5.0 DESIGN FEATURES

5.1 SITE

FIGURE 5-1
 DAVIS BESSE NUCLEAR POWER STATION
 EXCLUSION AREA

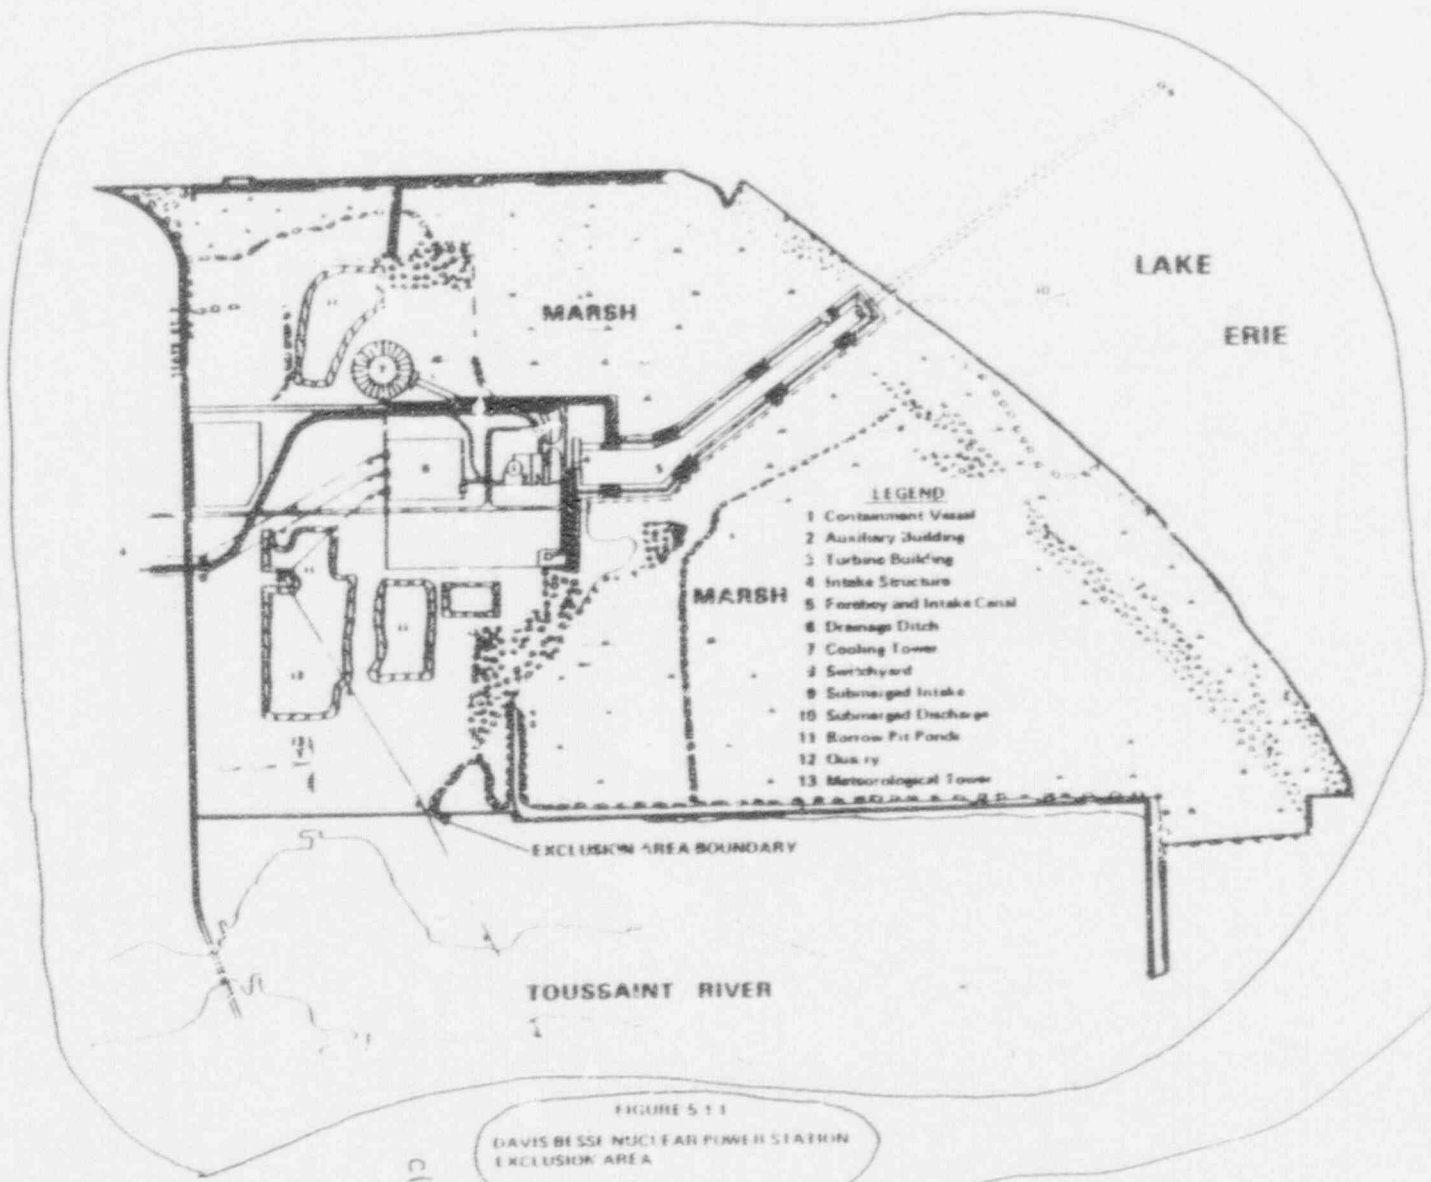
5.1.1 The exclusion area is ^{as defined in 10CFR Part 100.} ~~shown on Figure 5.1-1.~~

DELETED

FIGURE 5.1-2

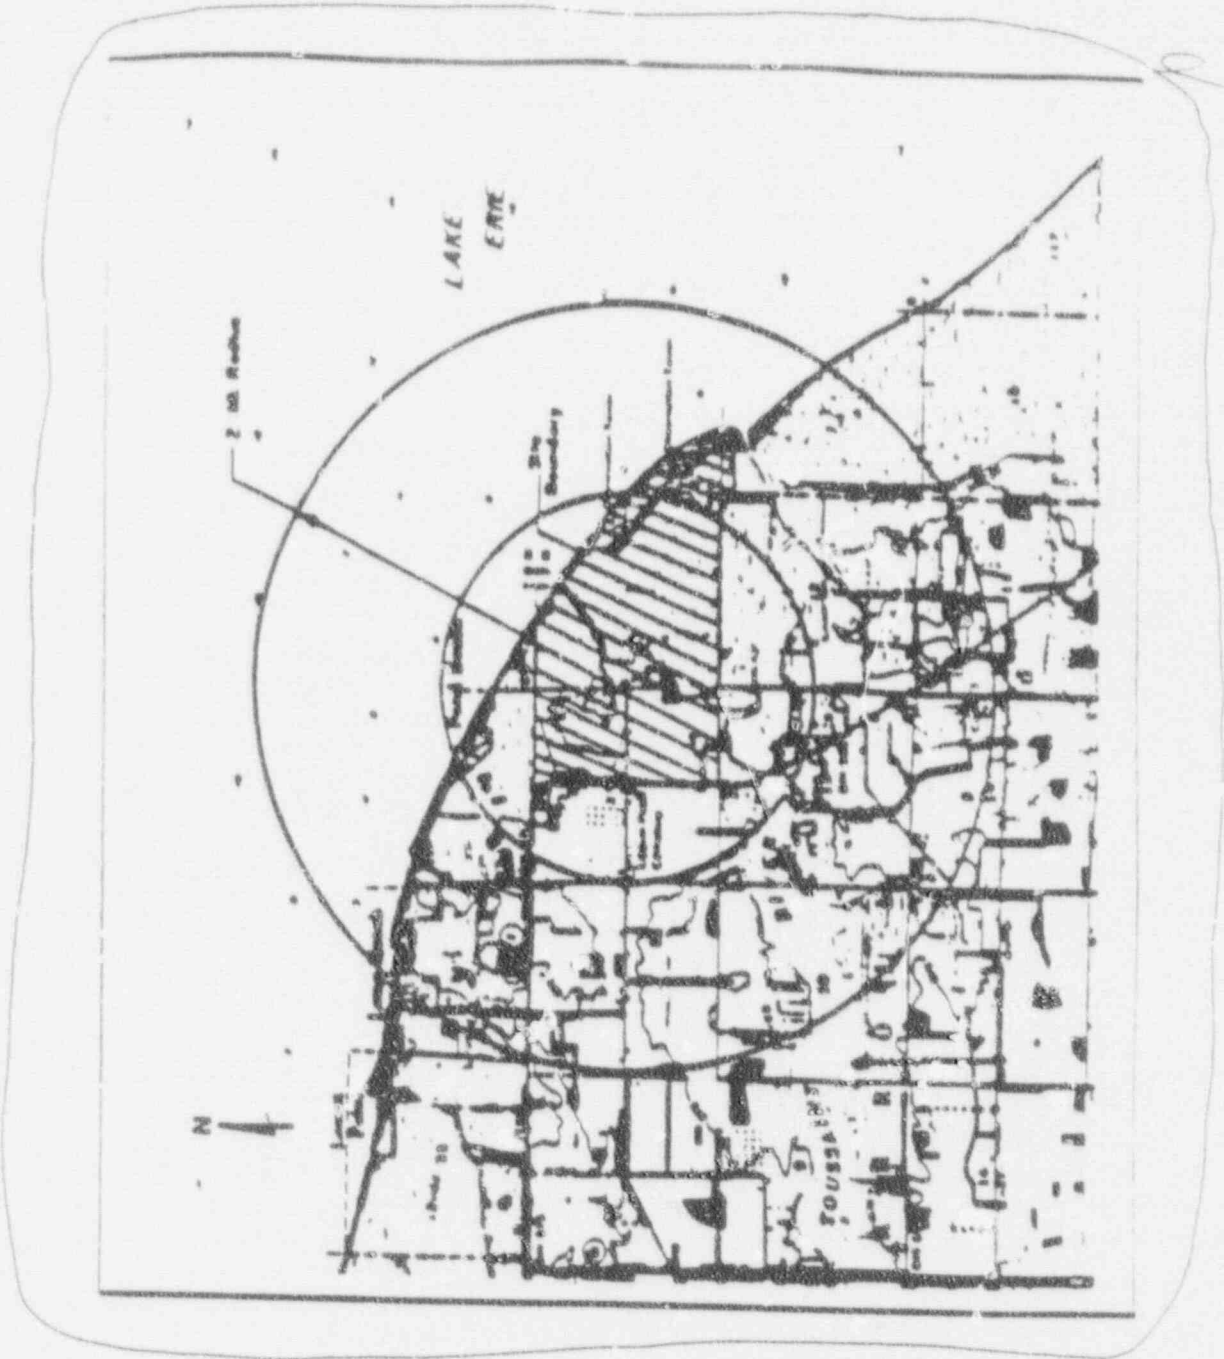
5.1.2 The low population zone is ^{as defined in 10CFR Part 100.} ~~shown on Figure 5.1-2.~~

DELETED

DAVIS-BESSE NUCLEAR POWER STATION
UNRESTRICTED AREA
BOUNDARY FOR LIQUID EFFLUENTS
Fig. 5-1-3

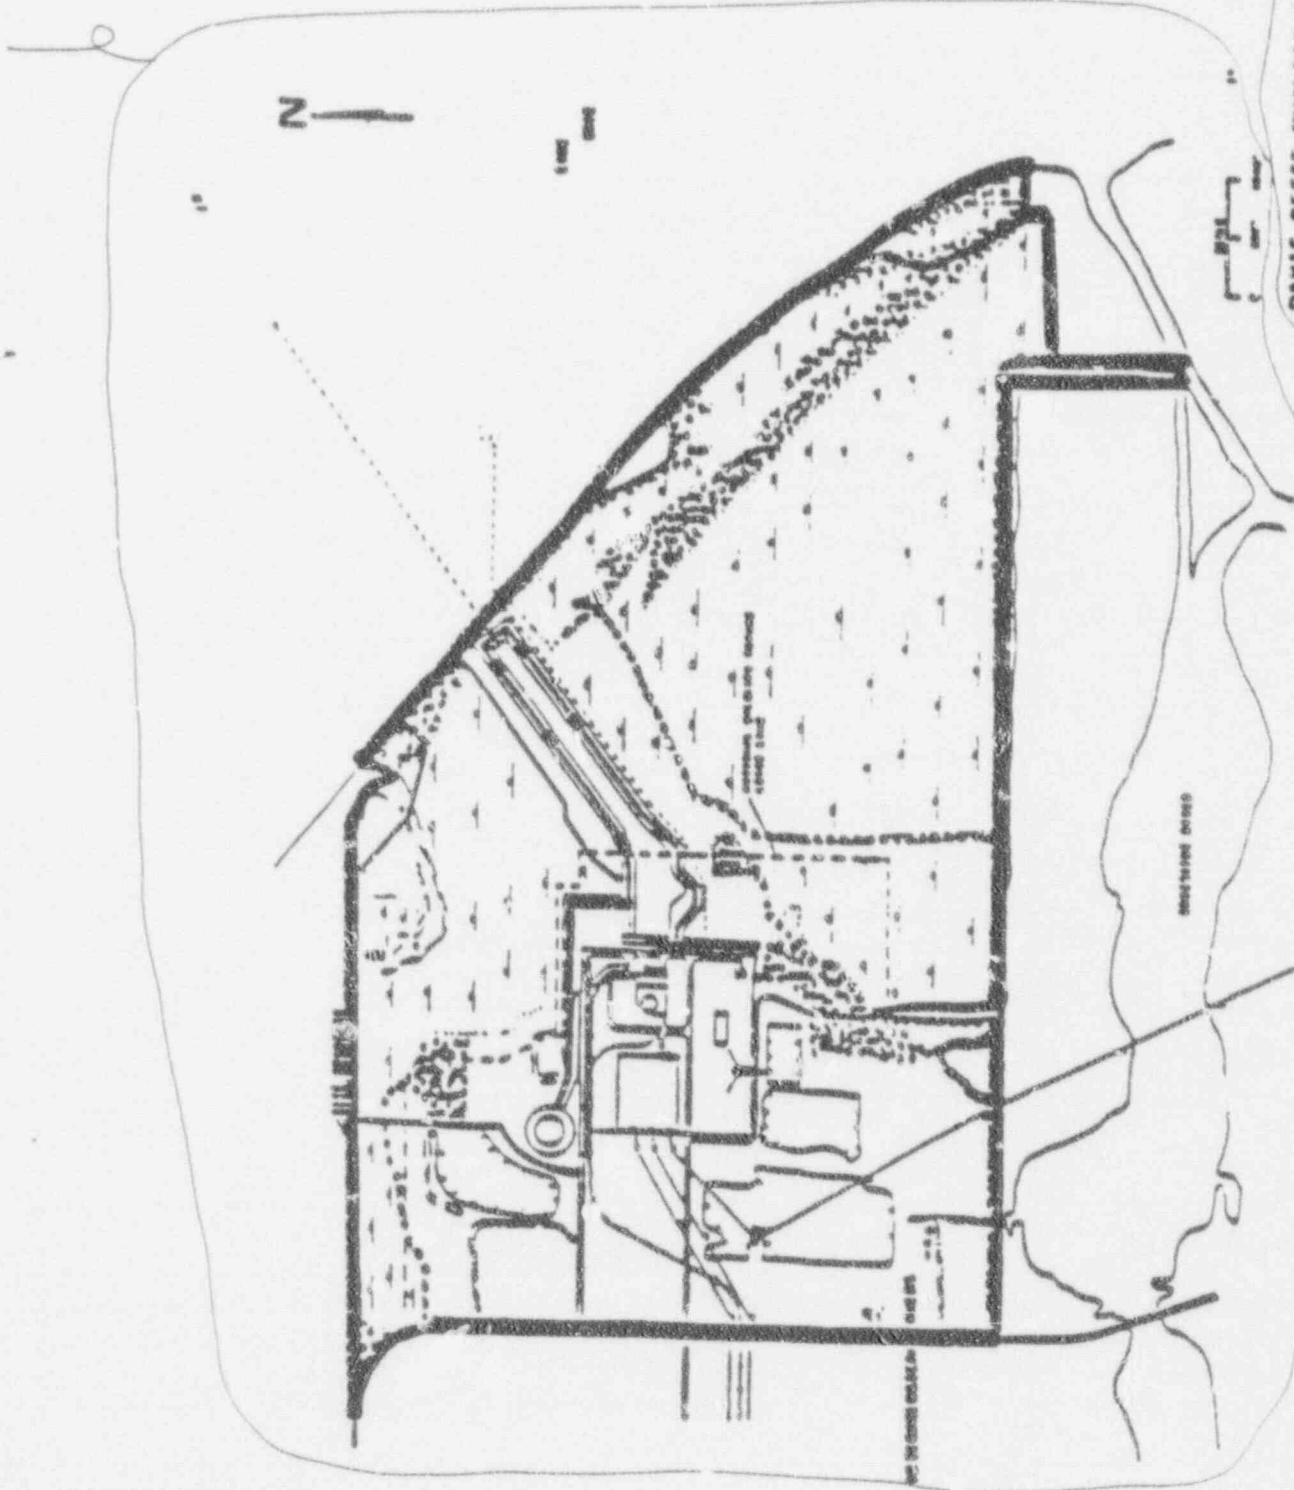
5.1.3 The UNRESTRICTED AREA and SITE BOUNDARY for radioactive liquid effluents is shown on Figure 5.1-3. The UNRESTRICTED AREA and SITE BOUNDARY for radioactive gaseous effluents is shown on Figure 5.1-4. *are defined in Technical Specifications Section 1.0, Definitions.*

DELETED
